SERVICE BULLETIN

No. 292 72 2212

ARRIEL 2 B - B1 - B1A - C - C-PM - C1 - C2 - C2-CG - D - E - H - N - S1 - S2

Subject: Module M02 (Axial compressor). Replacement of front and rear axial bearings.

Figure 1

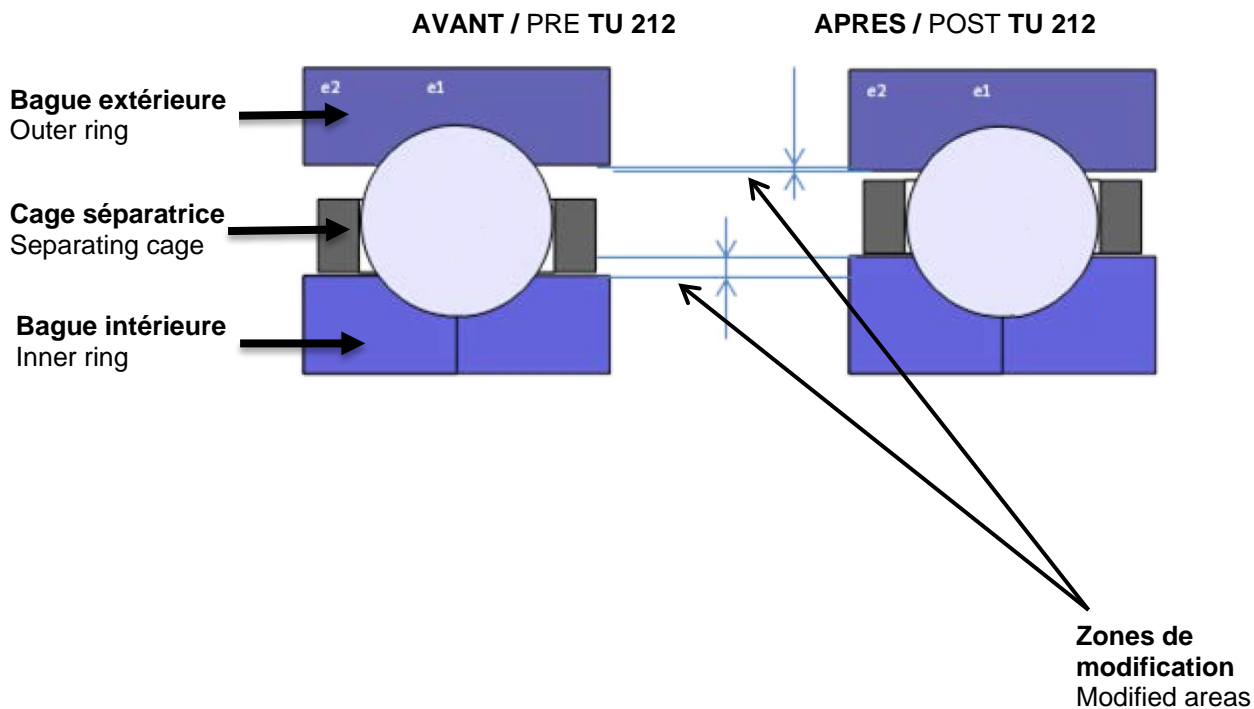
1.3. Description (see Figure 1)

Modification TU 212 mainly increases the shoulder height of the inner and outer rings of the bearing which should reduce flaking.

In the interests of commonality, the current front axial bearing will also be replaced with one that is dimensionally identical to the modified rear axial bearing.
